株式会社 WACOM CO., LTD.	設計 99.3.24	製図 99.3.24	承認 99.3.24
名称 MOUSE	型式 73A	図番 10	REV. 1

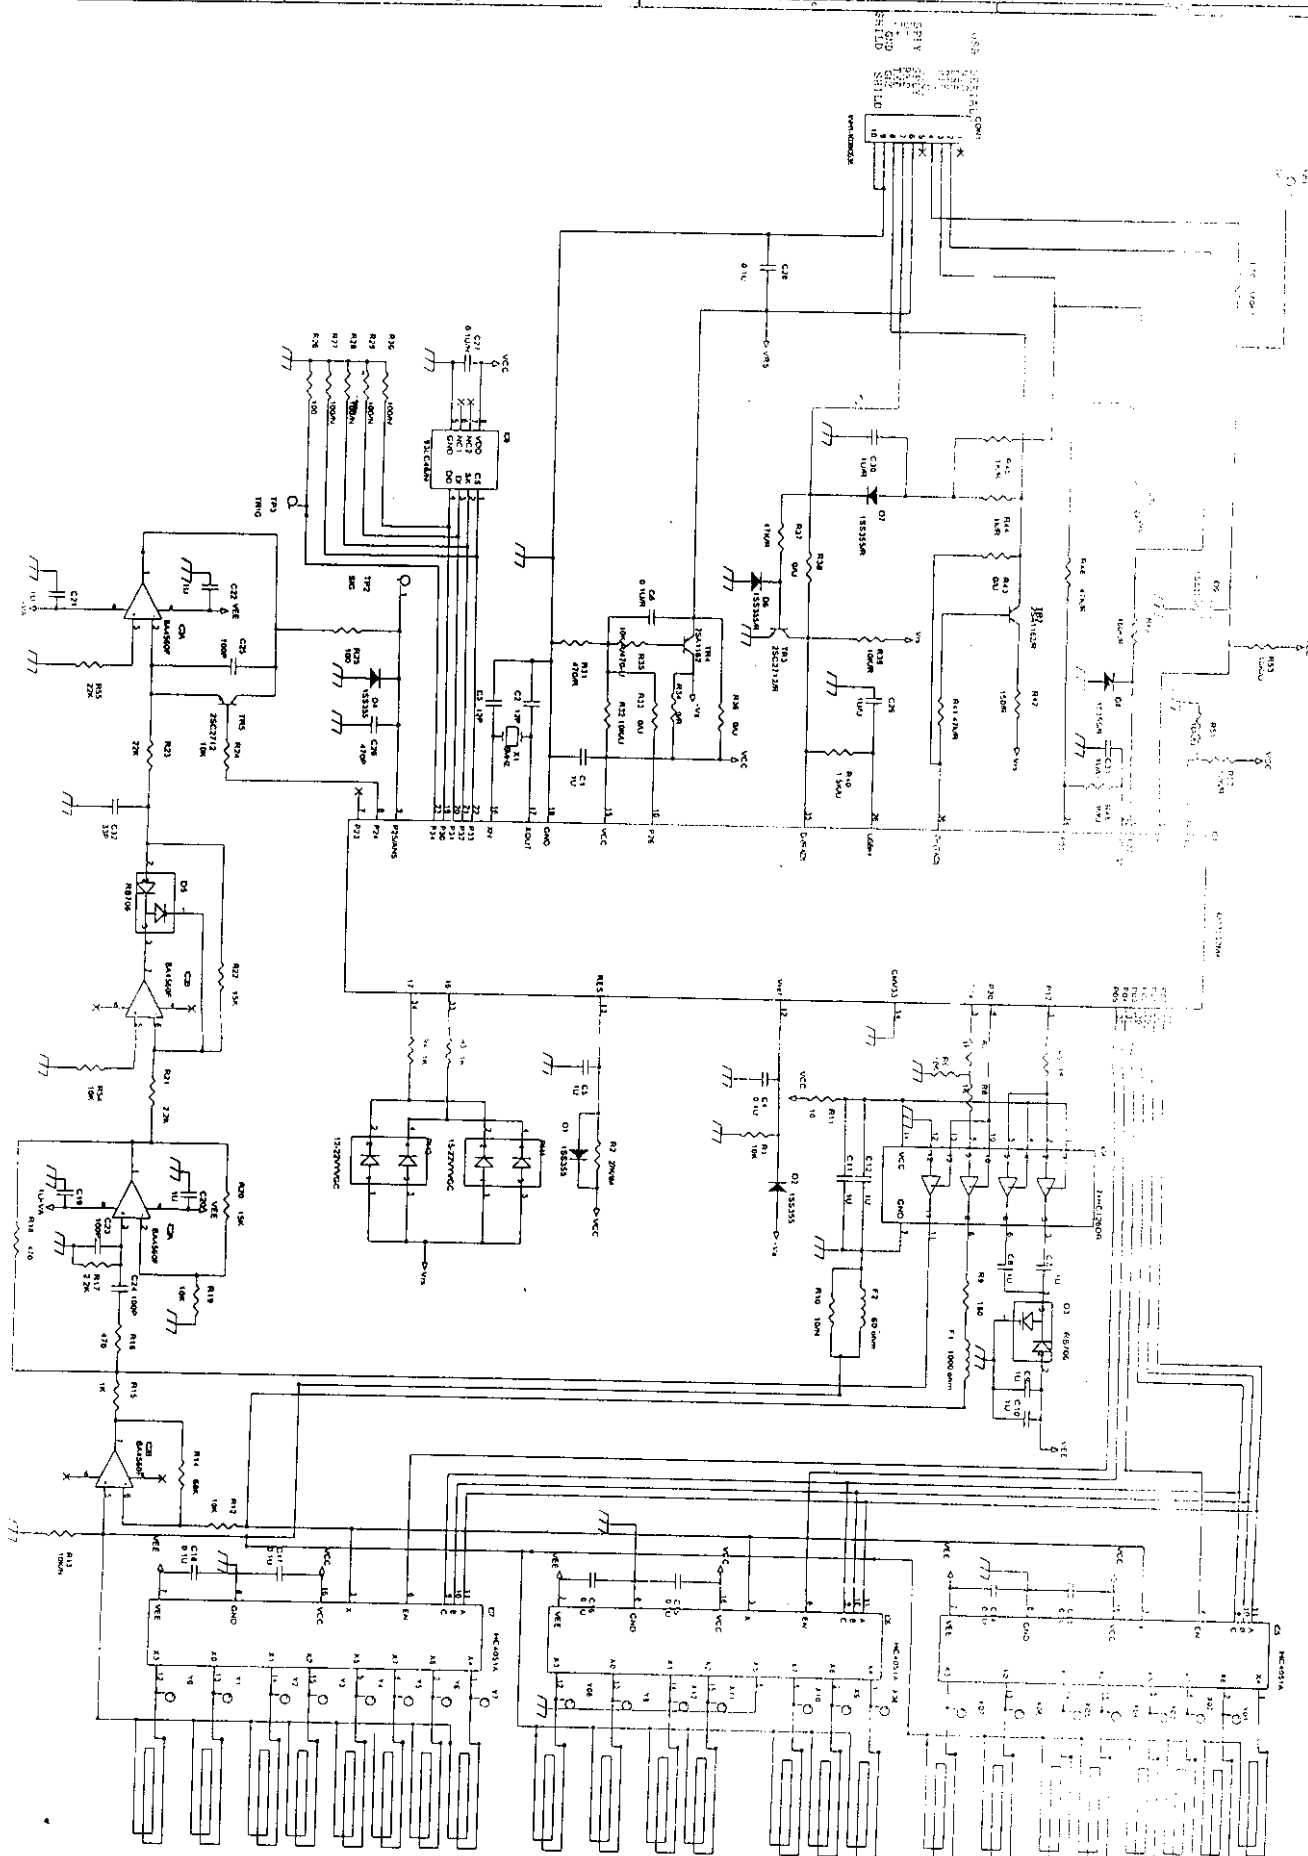
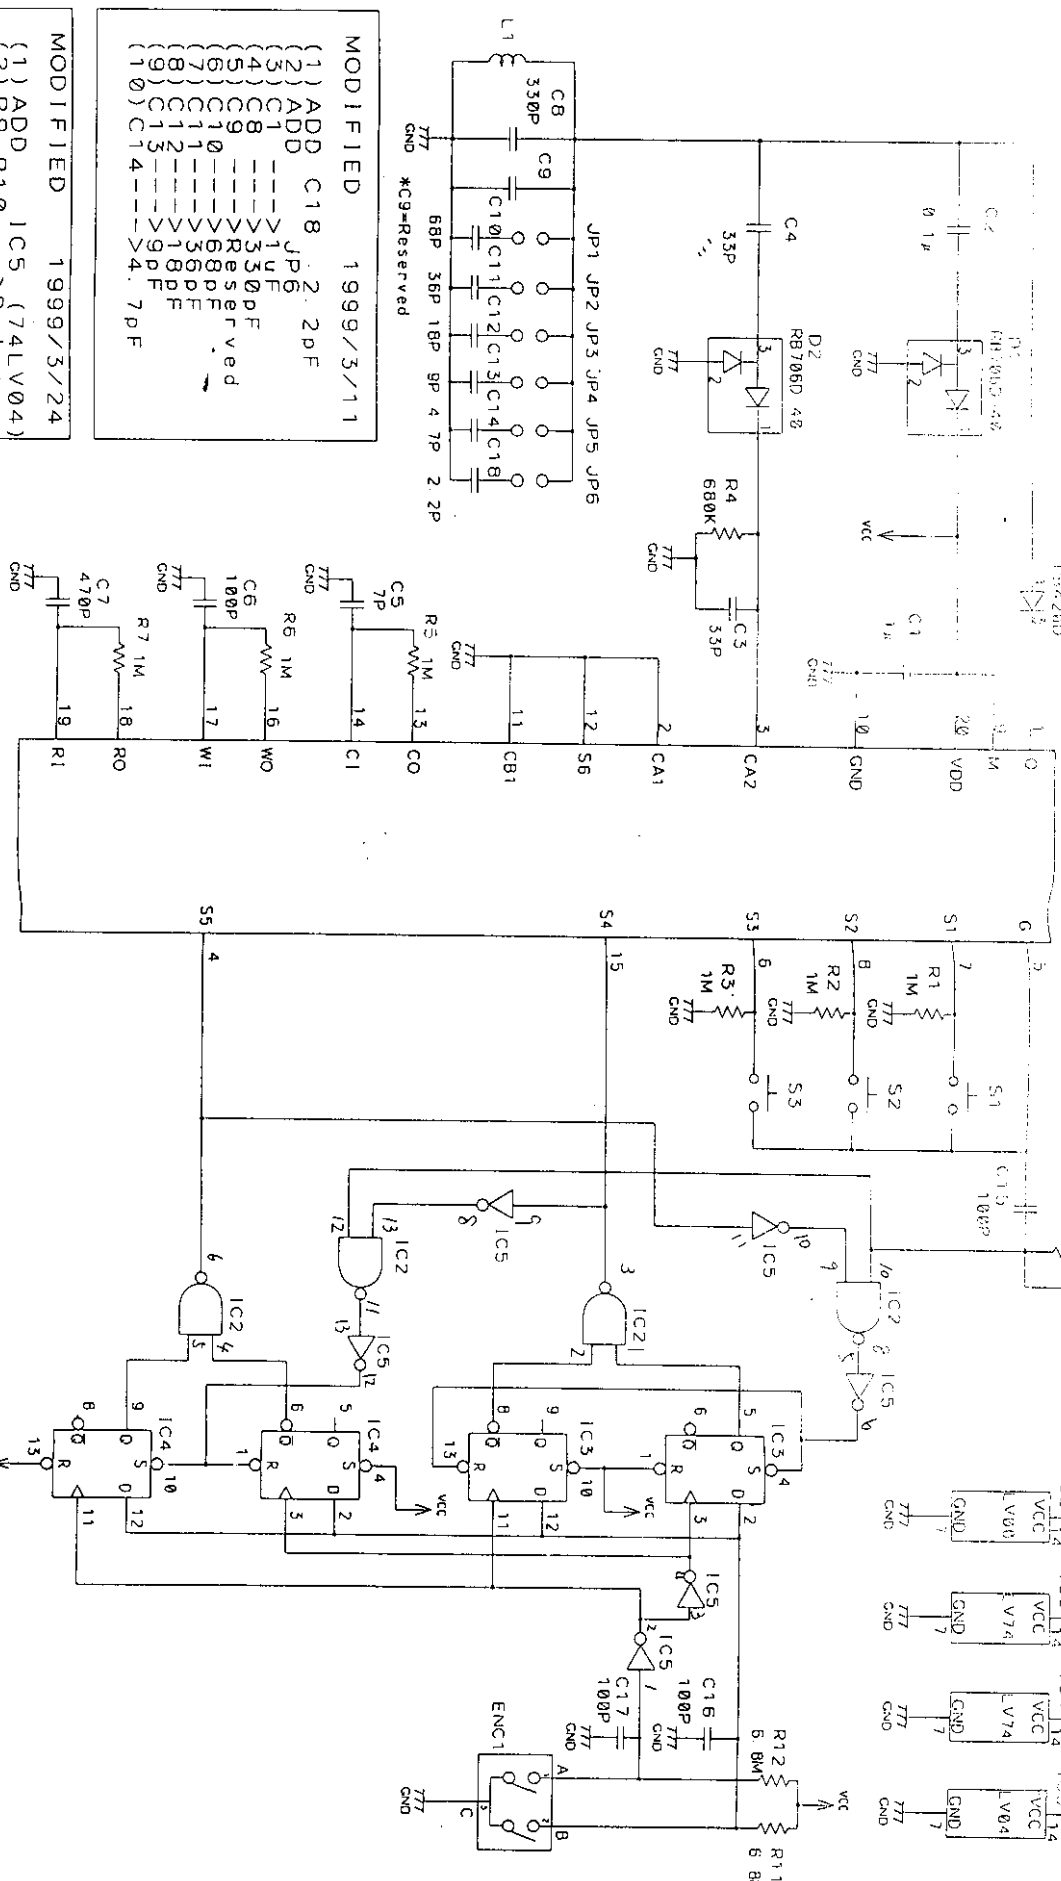
- MODIFIED 1999/3/11
- (1) ADD C18 2.2pF
 - (2) ADD JP6
 - (3) C1 > 100pF
 - (4) C8 > 330pF
 - (5) C9 > 100pF
 - (6) C10 > 100pF
 - (7) C11 > 100pF
 - (8) C12 > 100pF
 - (9) C13 > 100pF
 - (10) C14 > 100pF

- MODIFIED 1999/3/24
- (1) ADD IC5 (74LV04)
 - (2) R9 > 10k
 - (3) R11 > 10k
 - (4) C16, C17 > 100pF
